COMPLIANCE REPORT

9A000248
August 9, 2011
Final

Main Report

Xayaburi Hydroelectric Power Project
Run-of-River Plant

Figure 1: General layout of the upstream migration fish passage facility

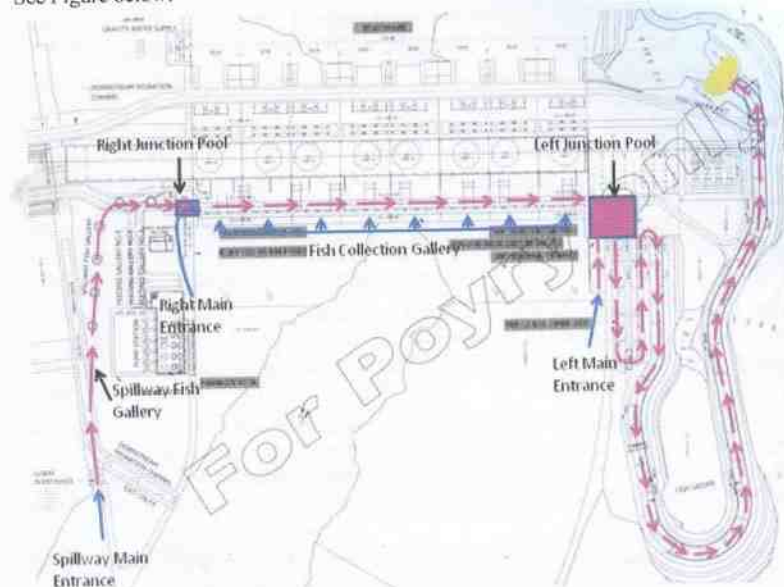
In general, the planned system is quite comprehensive, employs a state-of-the-art technology and covers all operational conditions of the scheme. However any changes after construction might be quite difficult to implement and therefore adaptations are recommended to be done already during the early construction phase. For the downstream migration a combination of Surface Bypass Collectors (SBC) avoiding turbine passage, the use of fish-friendly turbines and improved spill operations are recommended in the feasibility study.

Figure 2: Location of additional fish pass facilities

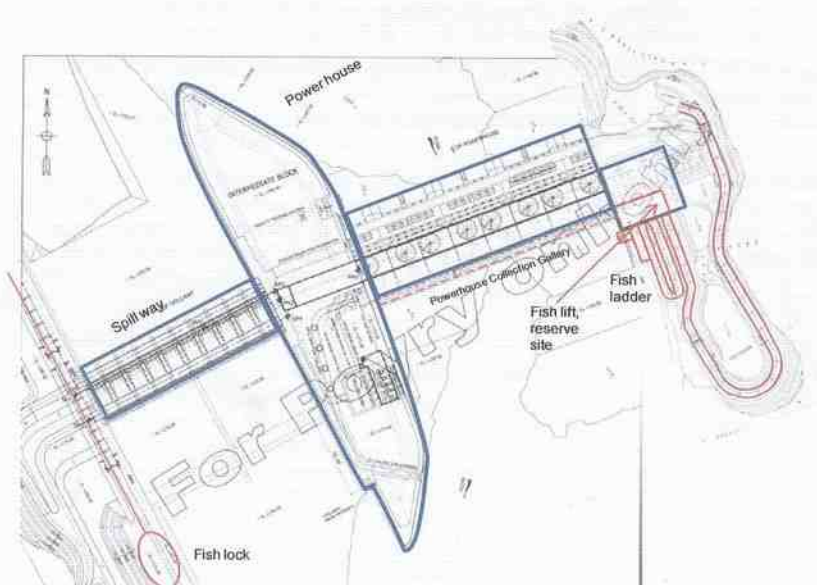
These adaptations are recommended in order to ensure that the Xayaburi HPP will be fully in compliance with the various existing and future (if any) requirements of the MRC Guidelines. These adaptations are recommended to be carried out during early construction phase.

Figure 3: Spillway section with flushing gate and flap gate;
Normal operation: flushing gate closed and no spillage through spillway

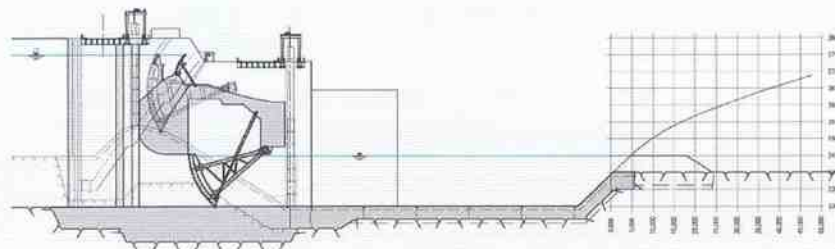
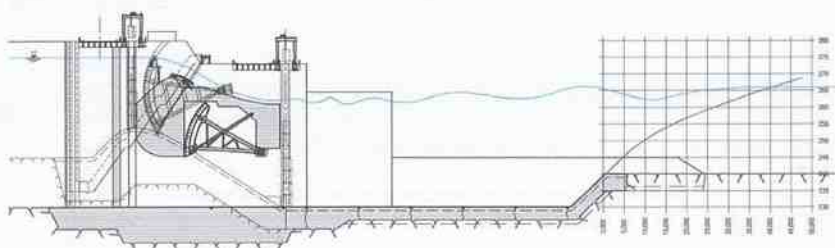
It is considered that the most suitable location to provide such flushing gates is in some of the spillway openings. It is recommended to use in maximum 5 spillway bays and this will allow the pass-through of sediment loaded inflows and the venting of possible turbidity currents (flows along the reservoir bottom containing higher concentrations of sediments).

There would be two flush gates per spillway bay, equipped with radial gates and with a base level of up to 24 m lower than the current spillway sill level and gate sizes of 8.0 m width. A simple flap gate would be sufficient to close the top part of the spillway opening.

Figure 2.1: Plan view of the upstream migration facility

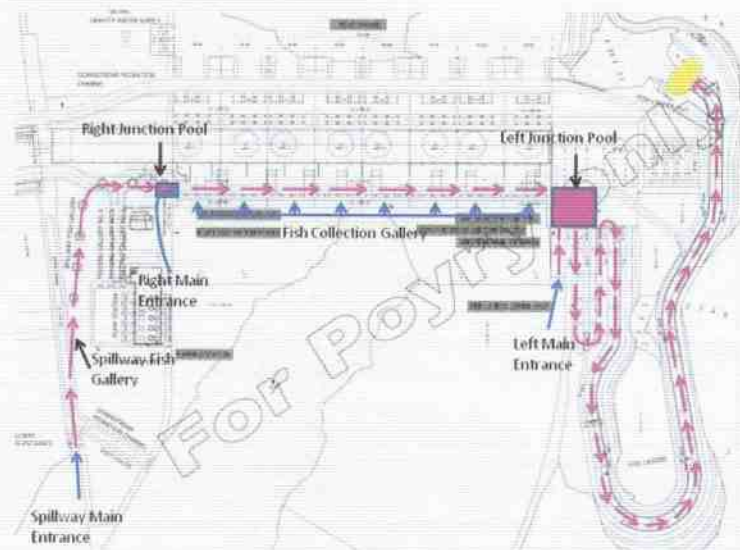
The three main entrances of the fish passage facility are located on strategically good positions and in addition the Powerhouse Collecting Gallery will transfer the fish in the middle of the powerhouse to the left fish pass. The velocity of the water through slots and orifices and the slope of 4.5% (Drawing no. XB -1611) and 5% (Feasibility Report) for the substrate layer of fish ladder are in the range which is commonly used for fish passes in Europe and North America, but it is probably too much for Mekong species, the drop height between the pools should not exceed 15 cm to allow small fish and weak swimmers to migrate up stream.

The presented design of the pools is very schematic, size and location of the slots and orifices in partition walls between the pools are not described. Drawing no. XB -1611

depicts the length of the pool with 4 m and the Feasibility Report described it with 7.5 m. It is correctly stated in the Feasibility Report that the minimum length of the pool is a function of the size of the fish to be given passage, therefore the pool length should not be smaller than 6 m. The bottom layer is 50 cm high consisting of rocky blocks in the same range of size. It is essential that the surface of the pool bottom is roughened by using river boulders with a suitable size to give weaker swimmer or juvenile fish the chance to rest. It will be important to provide enough resting zones or even additional resting pools (half way up the left fish pass). In general fish collection gallery should be in daylight since diurnal fish avoid swimming into dark channels or it must be lit artificially in a such a way that lighting is as close as possible to natural light (Fish Passes, Design, Dimension and Monitoring; FAO, DVWK 2002), but this can be investigated in a later stage.

Figure 2.3: Spillway section with flushing gate and flap gate;
Normal operation: flushing gate closed and no spillage through spillway

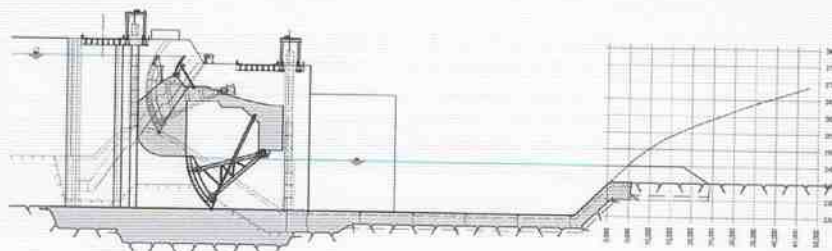
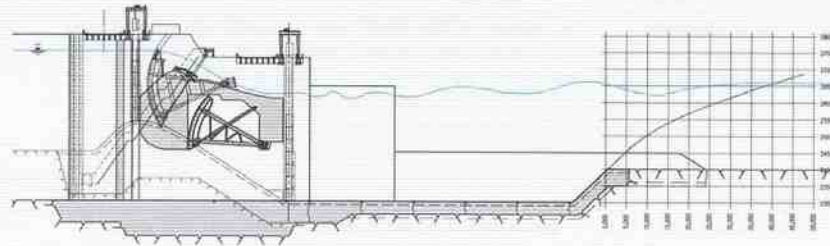
The overall capacity at each spillway bay shall remain the same one covered by two modified low level outlets. The flap gates are placed above the flushing gate chamber will only be used to pass safely floating debris during flood occurrences and for extreme floods.

- During flood events the hydraulic jump will travel further upstream leading to a situation that flow conditions at the weirs will be submerged creating ondular waves and unfavourable rollers

A systematic modelling for different flow conditions is recommended.

Negative impacts on the stability of the spillway structure are expected to be negligible. Stability safety margins remain similar comparing the design of spillway bays with radial gates with the proposed design of spillway bays with flushing gates. However, the concrete volume will increase by 26'000 m³ and excavation volume by 23'000 m³ per spillway bay with flushing gates. Additionally, costs of such flushing gates including flap gates will increase by approximately 20% compared to the radial spillway gates.

Figure 2.6: Drawdown water levels in reservoir

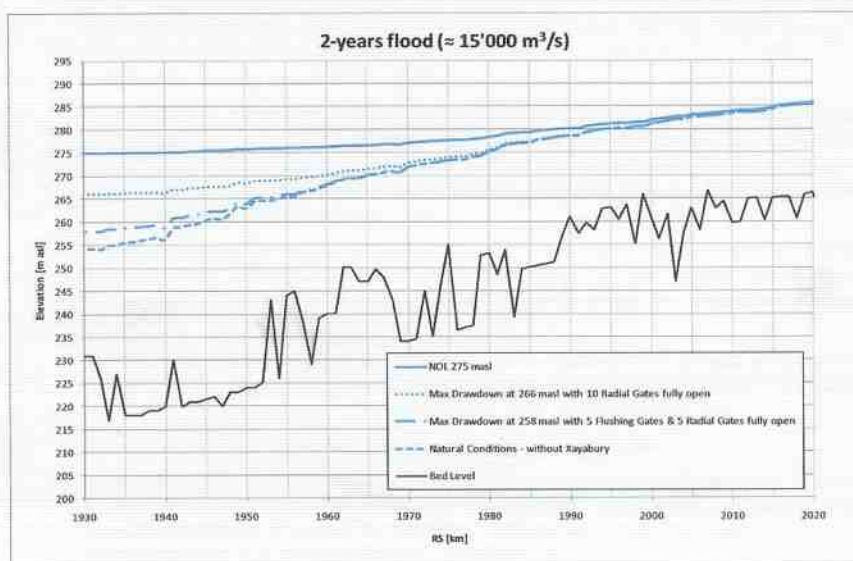
The resulting backwater curves with or without any drawdown are shown in Figure 2.6.

During a 2 years flood the water level will be constant at el. 275.00 from Xayaburi (RS 1905) up to RS 1930. Further upstream backwater effects are expected up to RS 2000, i.e. 70 km u/s of Xayaburi. Due to technical limitations the reservoir can only be lowered during such a flood event down to el. 258, which is about 4 m above the natural water level at the dam site. Hence, the length of the backwater effects is reduced to 25 km (Figure 2.6, RS: 1930 – 1955).

The resulting backwater curve (up to km 1970) has to be compared to the natural conditions. Generally it is assumed that sediments in the backwater reach will not or only partially be mobilized and will not pass the barrage completely. Suspended sediments may even deposit in the lower reach additionally and fill natural pools.

Figure 2.7: Boundary conditions for energy production.

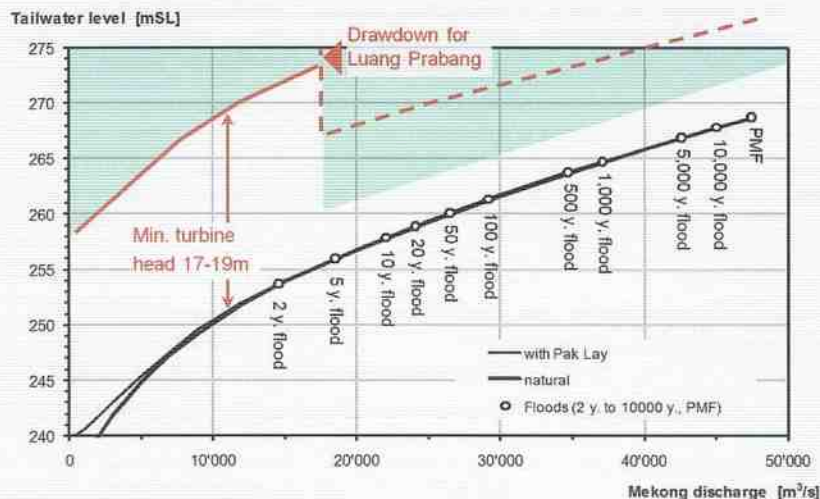
Some information on this can be obtained when relating the boundary conditions for energy production to the tailwater levels (Figure 2.7):

- Full supply level FSL is at 275.00 m asl.
- The minimum head required to operate the turbines is between 17 and 19 m. Relating to the tailwater levels, this leads to a curve for the minimum required reservoir level (plain red line in Figure 2.7).
- Above Mekong discharges of 18,000 m³/s, the reservoir has to be drawn down to protect Luang Prabang. This corresponds to a 5-years flood. As can be seen from Figure 2.1 (right part), operation of the turbines is then no longer possible, since the

minimum head required is not available. For the present spillway design, the minimum reservoir level is then essentially determined by the spillway capacity.

As a result, a shaded area is given in Figure 2.7 which shows the range for possible drawdown without stopping the energy production completely. For discharges above 18'000 m³/s the shaded area can be extended below the spillway capacity curve. Suitable low level flushing outlets are to be provided then.
